**Planning & Environment**
Issued under the Environmental Planning and Assessment Act 1979
Approved Section 4.55 (.....) Modification Application
No. 3 granted on the 8 May 2019
in respect to SSD 7484
Signed AD
Sheet No. 1 of 33

PROJECT
**SANDSTONE
PRECINCT**
23-39 BRIDGE STREET, SYDNEY 2000, AUSTRALIA

PROPOSED SITE PLAN

DRAWING NUMBER
SP-DA-G-1500

PROJECT NUMBER 1166
SCALE 1:200@B1
DRAWN BV
CHECKED CZ
STATUS
FOR APPROVAL
DRAWING
PROPOSED PLANS
EDUCATION BUILDING - BASEMENT 03

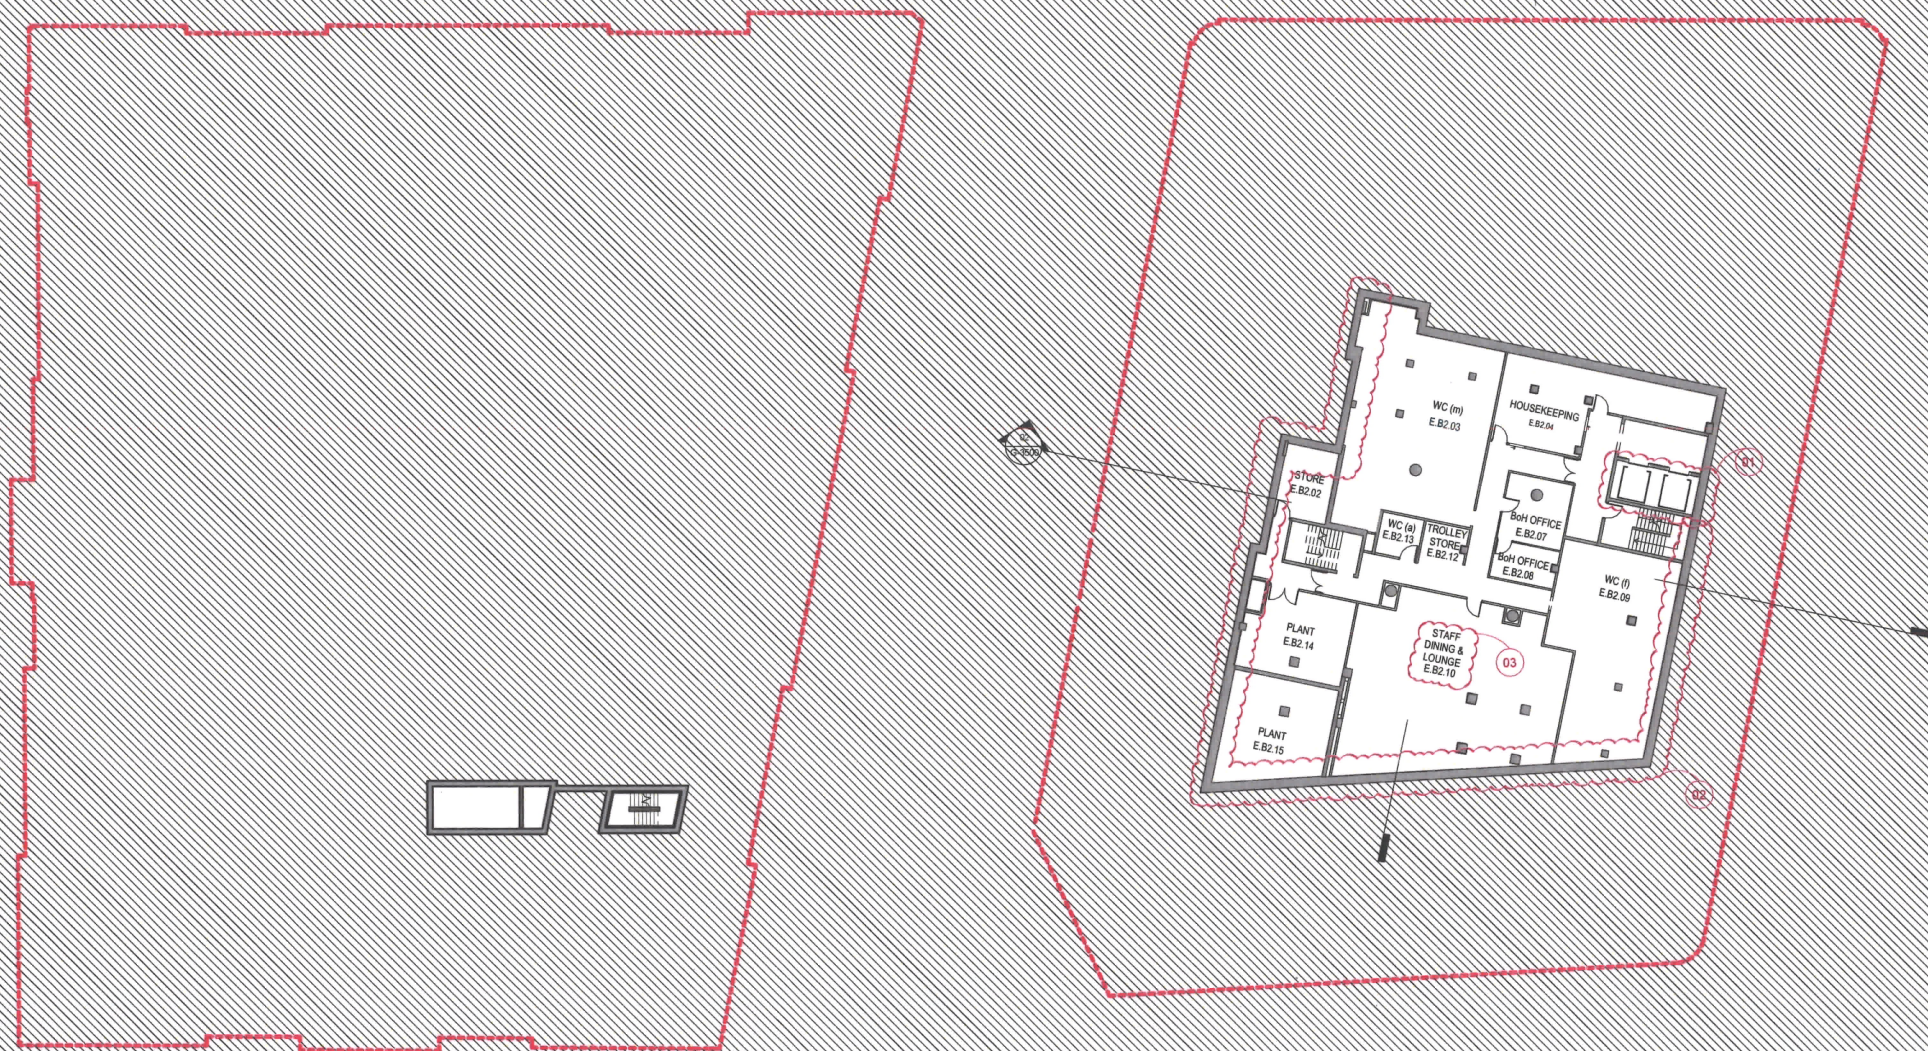
CHANGES LEGEND:
 01 REDUCTION OF 4 B&H LIFT TO 2 FROM THE BASEMENT LEVELS TO FARRER PLACE
 02 EXTENT OF BASEMENT EXCAVATION REDUCED FOLLOWING GEO-TECHNICAL INVESTIGATIONS
 03 RELOCATION OF PRODUCTION KITCHEN TO B3

FOR APPROVAL
 DRAWING
PROPOSED PLANS
EDUCATION BUILDING - BASEMENT 02

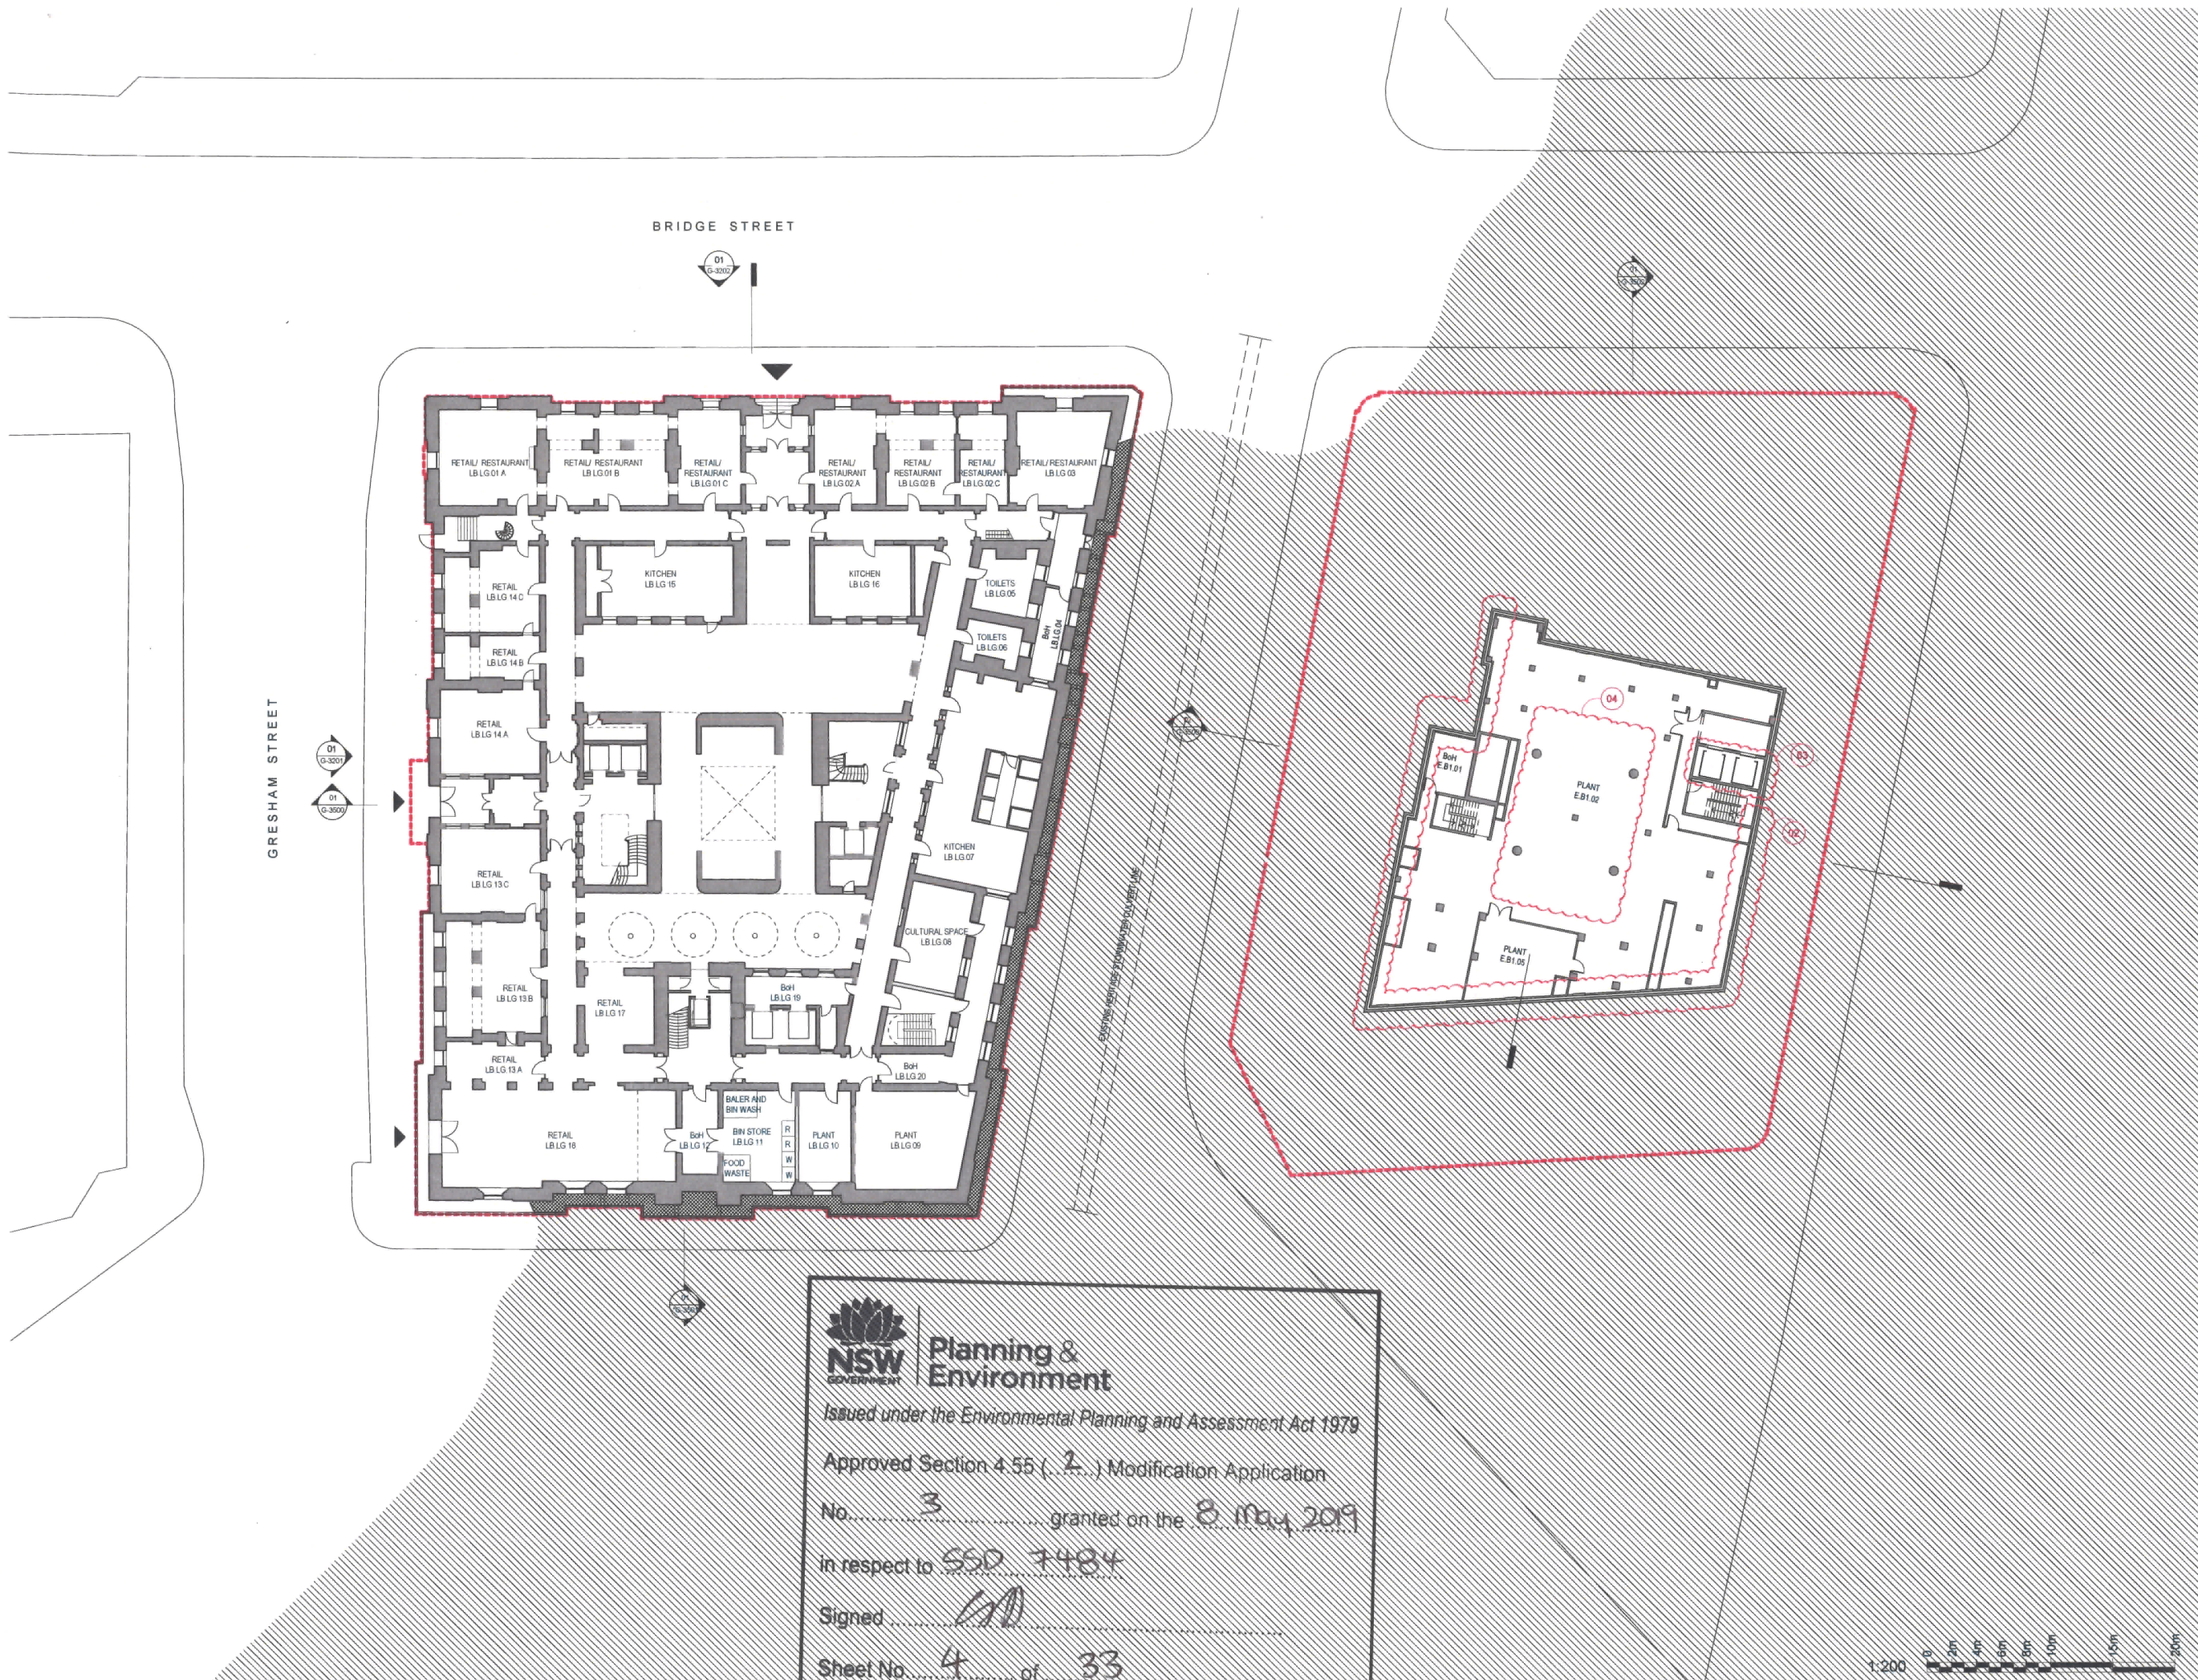
- CHANGES LEGEND:**
- 01 REDUCTION OF 4 B&H LIFT TO 2 FROM THE BASEMENT LEVELS TO FARRER PLACE
 - 02 EXTENT OF BASEMENT EXCAVATION REDUCED FOLLOWING GEO-TECHNICAL INVESTIGATIONS
 - 03 RELOCATION OF STAFF FACILITIES FROM B1 TO B2

LANDS BUILDING - LOWER GROUND, EDUCATION BUILDING - BASEMENT 01

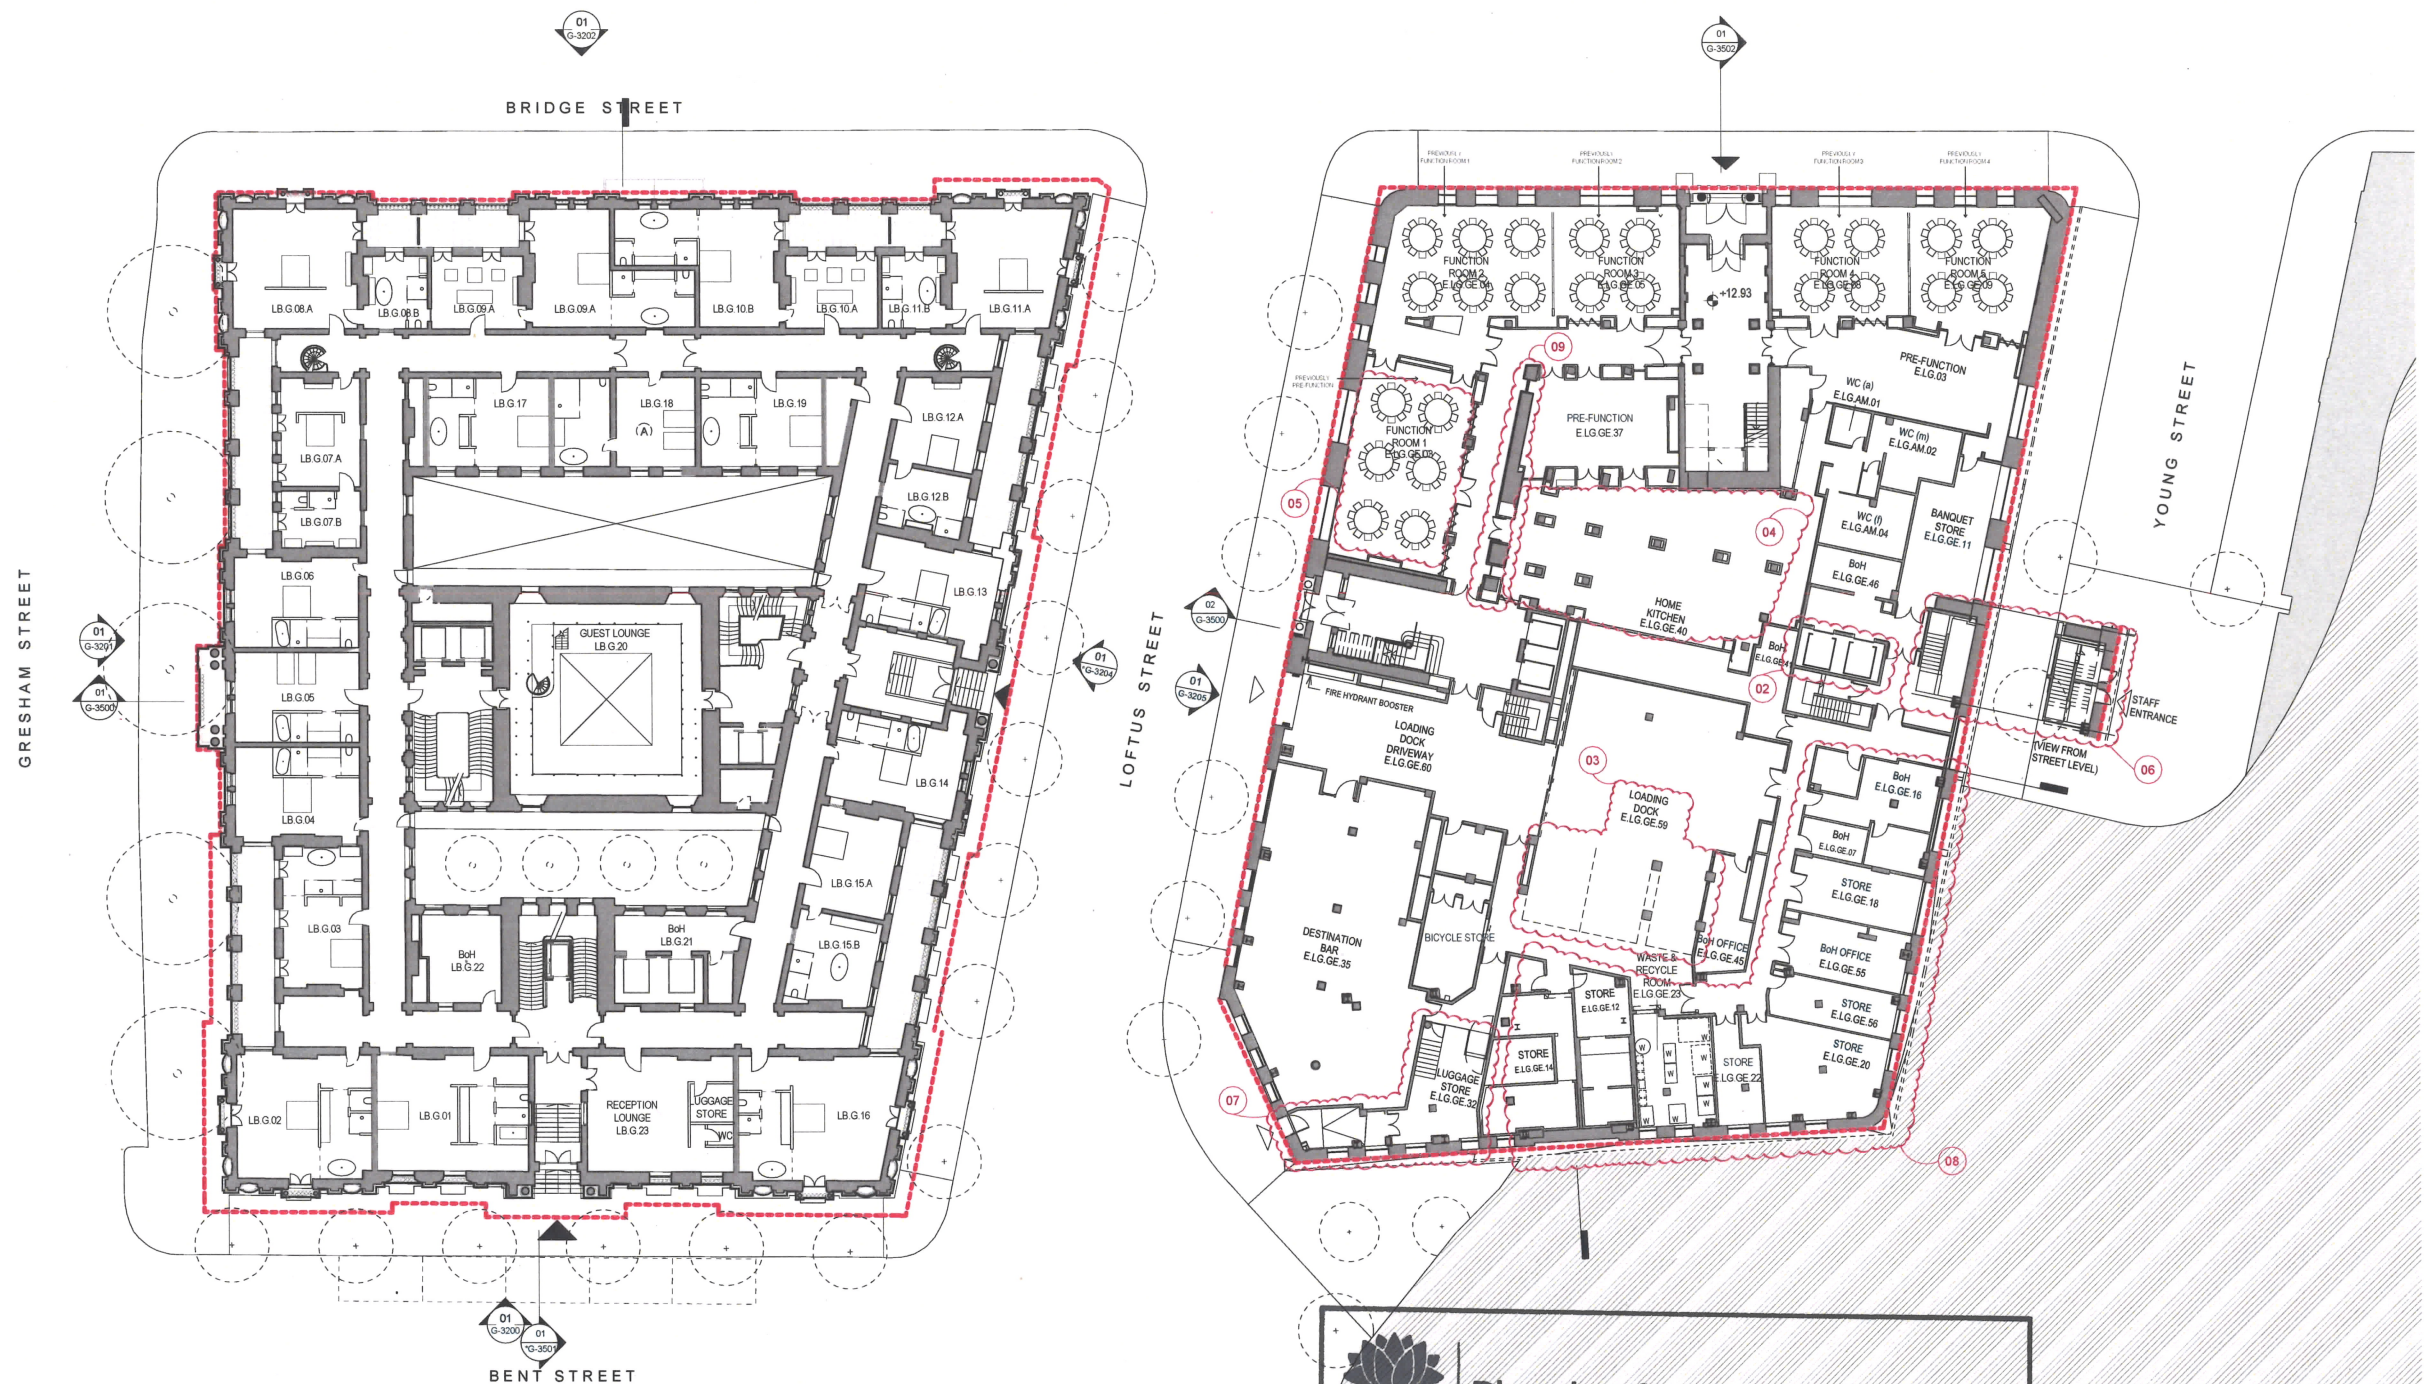
- CHANGES LEGEND:
- 01 BALLROOM REMOVED
 - 02 EXTENT OF BASEMENT EXCAVATION REDUCED FOLLOWING GEO-TECHNICAL INVESTIGATIONS
 - 03 REDUCTION OF 4 BOH LIFTS TO 2 FROM THE BASEMENT LEVELS TO FARRER PLACE
 - 04 RELOCATION OF PLANT FLOOR FROM B2 TO B1
